RECORD DWGS
AS FABRICATED
6/24/13

TOWN OF WARREN, VT
COUNTY OF WASHINGTON
BRIDGE NO.173 REPLACEMENT
WARREN, VT

DESIGN: SAF	DRAW: TLB	REVIEW: SAF/RLI	CHECK: CJG	SHEET: 9n	TOTAL: 58
SHOP DETAILS		PROFILES		USB JOB#	
				51622

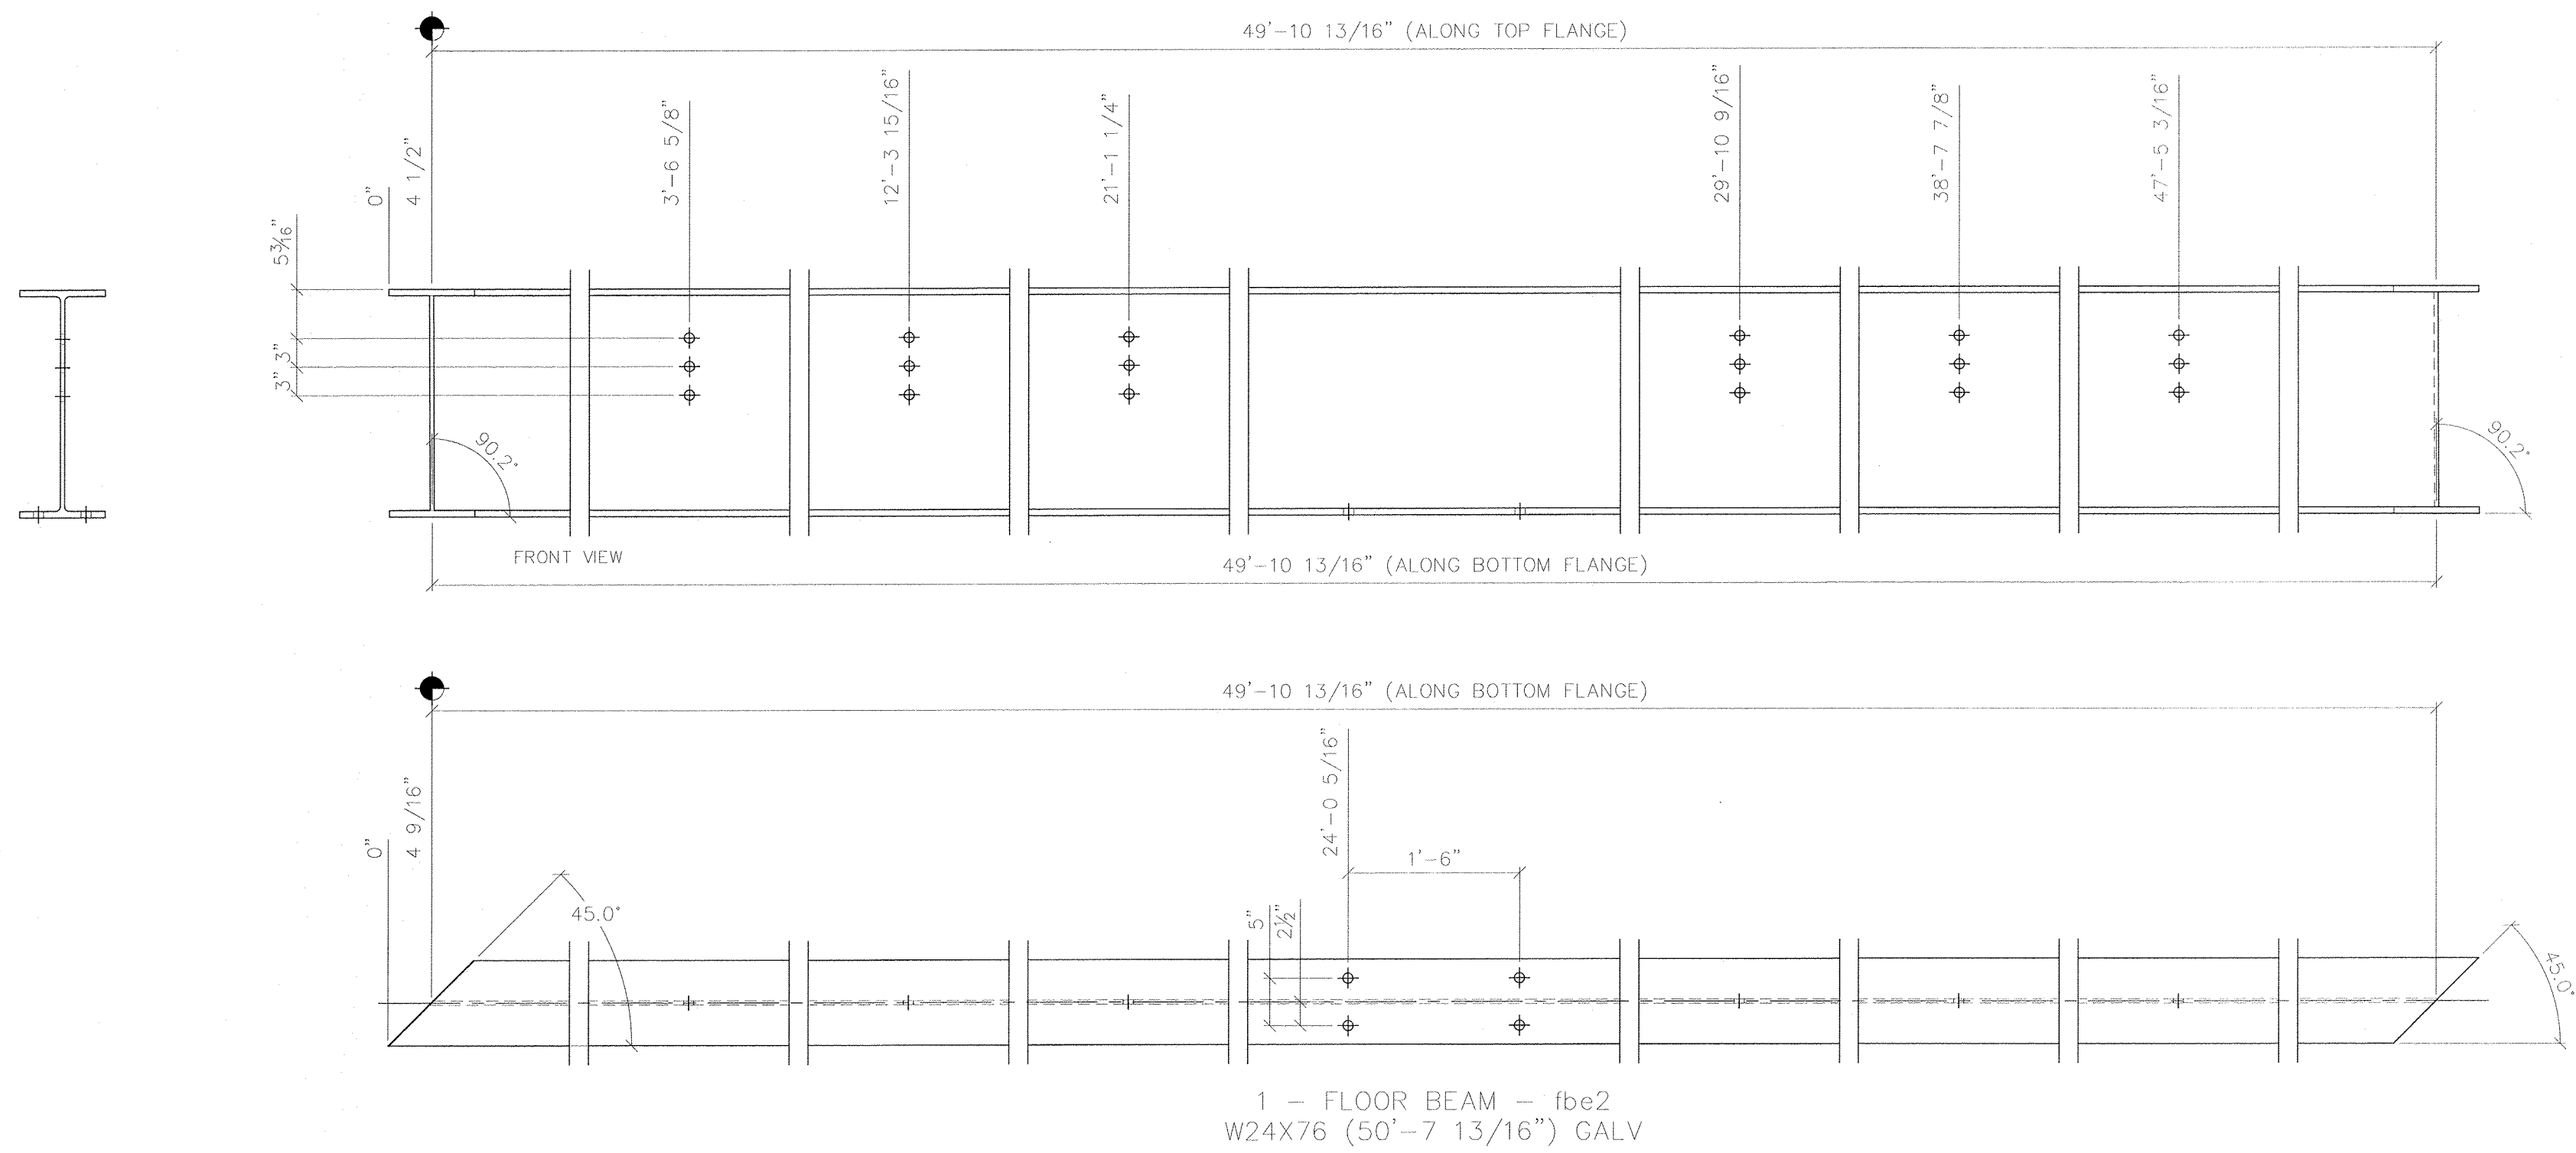
SUBMITTAL LOG	DATE	NO.	DATE	REVISIONS:	BY:
INITIAL SUBMITTAL	12/18/12	▲	5/15/13	FLOOR BEAM END PLATES WAS 1" THK	TLB
RESUBMITTAL NO. 2	2/5/13	▲	5/15/13	ADDED 2" DIA. RAT HOLES IN fb1 & fb9	TLB
CUSTOMER APPROVAL	2/13/13	▲	5/15/13	CHANGED WELD WAS 3/16" ALL AROUND	TLB
SHOP REVIEW	-	▲	5/15/13	CHANGED BOLT PATTERN	TLB
PRE FAB MTG	-	▲	5/15/13	WAS 2" EDGE DISTANCE	TLB
APPROVED FOR FAB	2/28/13	▲	6/3/13	DIMENSIONAL ERRORS	TLB
